Access Compliance Report Public Rights-of-Way (Curb Ramps)

Main Street: CHRISTY_LN Cross Street: ANGLER_LN Location: NE

ADA ID: RPRK211209113612 Ramp Type: Type 1 - Perpendicular Diagonal Initial Pass/Fail: Pass Overall Compliance: No Severity Score: 10

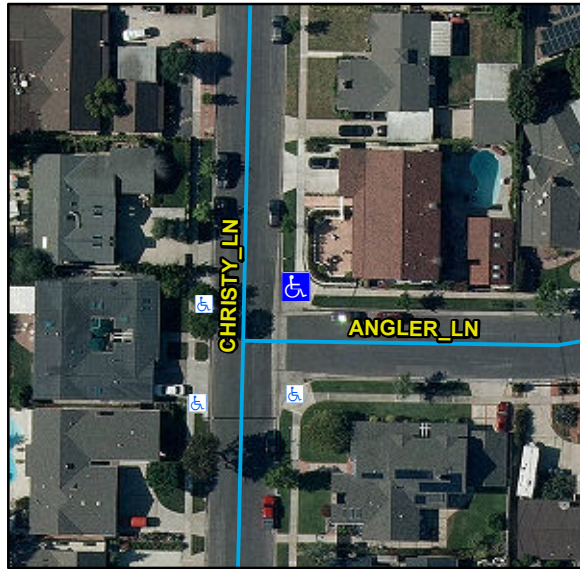
R204.3, R305, STD 1115

Remove & Replace Curb Ramp With Two New Directional Ramps or Equivalent.
